REMARKS

Matters of Form

FIG. 1 (PRIOR ART)

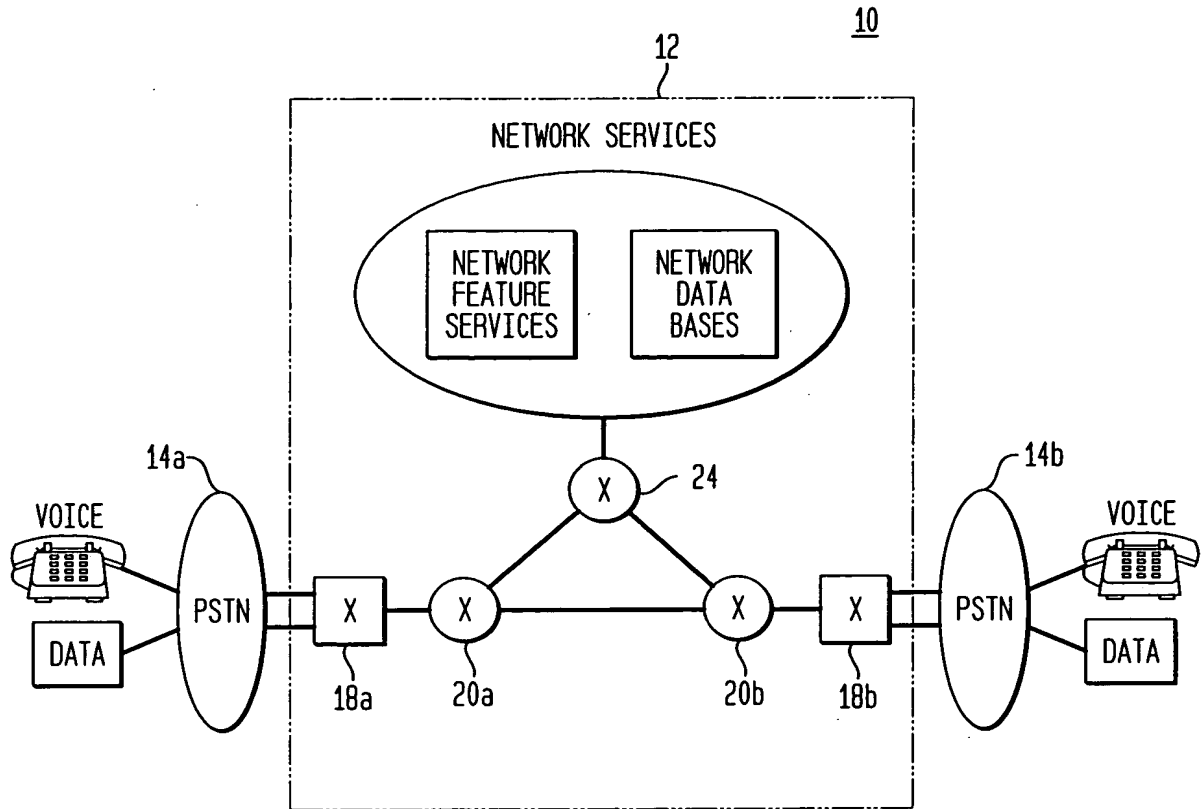
In Section 1 of the Office Action, the Office asserted that Figure 1 should be designated by a legend such as – PRIOR ART --. Applicant has amended Figure 1 accordingly.

FIG. 3A Annotated

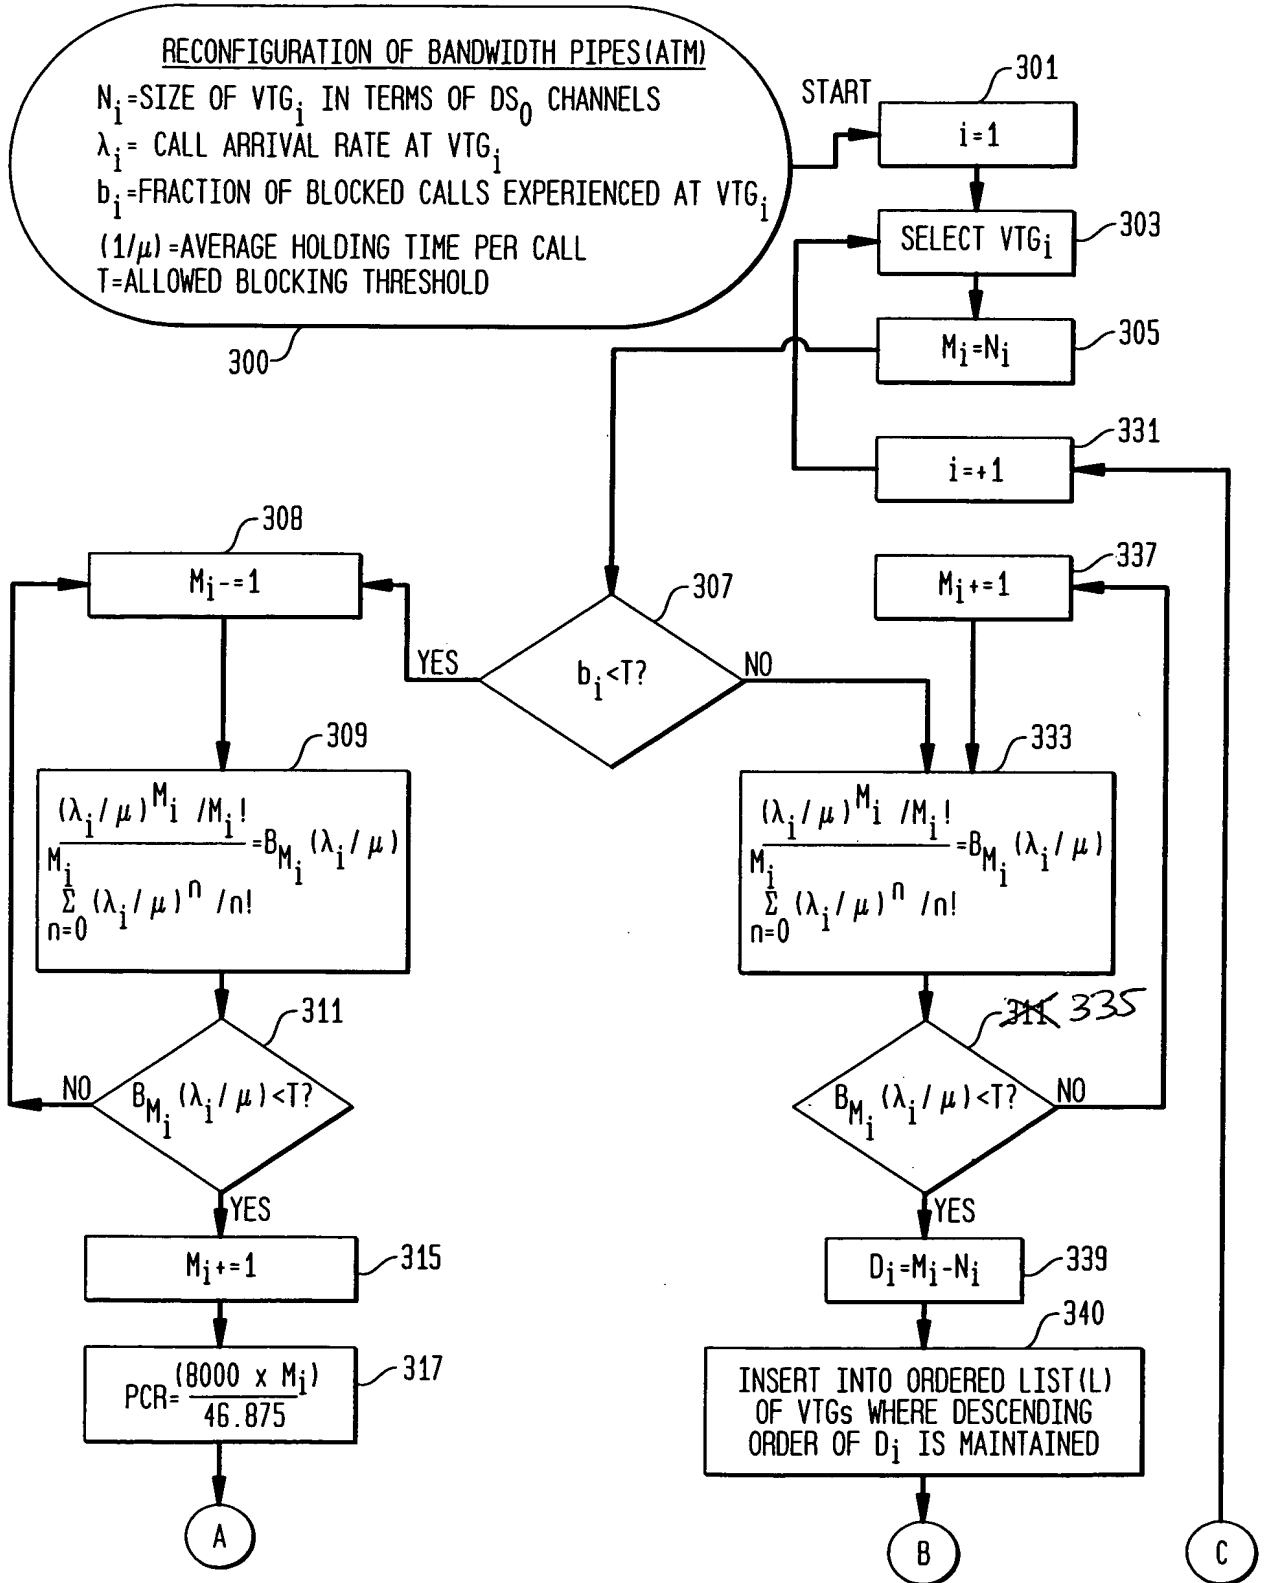
In Figure 3, reference numeral 311 located after reference numeral 333 is being relabeled as reference numeral 335 in order to be consistent with the description on page 25 of the specification. In Figure 9B, reference numeral 924 is being relabeled as reference numeral 935 in order to be consistent with page 56 of the specification. Applicant submits herewith proposed drawing corrections reflecting these changes.
